Well Name: SALT GRASS WS FEDERAL	Well Location: T14S / R27E / SEC 26 / NESE /	County or Parish/State: CHAVES / NM
Well Number: 1	Type of Well: CONVENTIONAL GAS WELL	Allottee or Tribe Name:
Lease Number: NMNM38476	Unit or CA Name: SALT GRASS WS FEDERAL COM	Unit or CA Number: NMNM72472
US Well Number: 300056194500S1	Well Status: Producing Gas Well	Operator: EOG RESOURCES INCORPORATED

Notice of Intent

**Salt Grass WS Federal 1
30-005-61945
EOG Resources Incorporated
June 14, 2021
Conditions of Approval**

Salt Grass WS Federal Com 1 Proposed

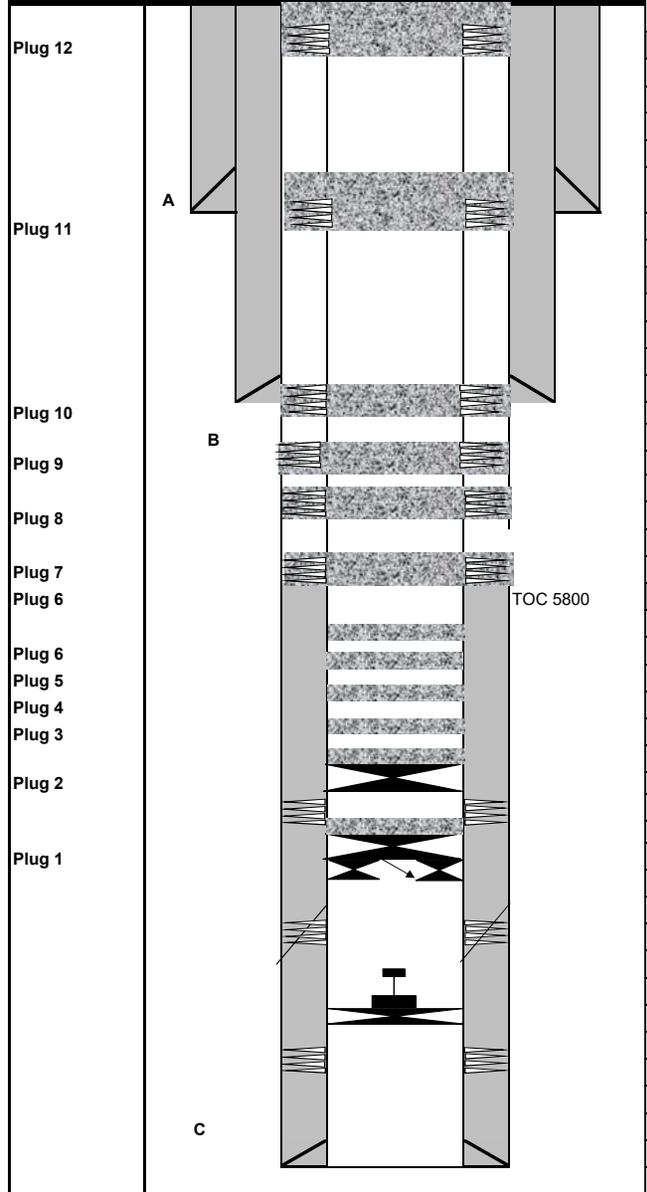
1. Operator shall place CIBP at 8,210' and places 25 sx of Class H cement on top as proposed. WOC and TAG.
2. Operator shall place CIBP at 8,077' (50'-100' above top most perf) and places 25 sx of Class H cement on top. WOC and TAG.

3. Operator shall place a balanced Class H cement plug from 7,665'-7,495' as proposed.
4. Operator shall place a balanced Class H cement plug from 7,465'-7,295' as proposed.

5. Operator shall place a balanced Class C cement plug from 7,001'-6,841' as proposed.
6. Operator shall place a balanced Class C cement plug from 6,154'-5,994' to seal the top of the Wolfcamp as proposed.

7. Operator shall perf and squeeze at 5,800'. Operator shall place a balanced Class C cement plug from 5,800'-5,650' as proposed. WOC and TAG.
8. Operator shall perf and squeeze at 5,040'. Operator shall place a balanced Class C cement plug from 5,040'-4,900' to seal the top of the Abo. WOC and TAG.

9. Operator shall perf and squeeze at 2,400'. Operator shall place a balanced Class C cement plug from 2,400'-2,200' as proposed. WOC and TAG.
10. Operator shall perf and squeeze at 1,600'. Operator shall place a balanced Class C cement plug from 1,600'-1,500' to seal the 8-5/8" casing shoe. WOC and TAG.

11. Operator shall perf and squeeze at 350'. Operator shall place a balanced Class C cement plug from 350'-250' to seal the 13-3/8" casing shoe. WOC and TAG.

12. Operator shall perf and squeeze at 100'. Operator shall place a balanced Class C cement plug from 100' - surface as proposed.
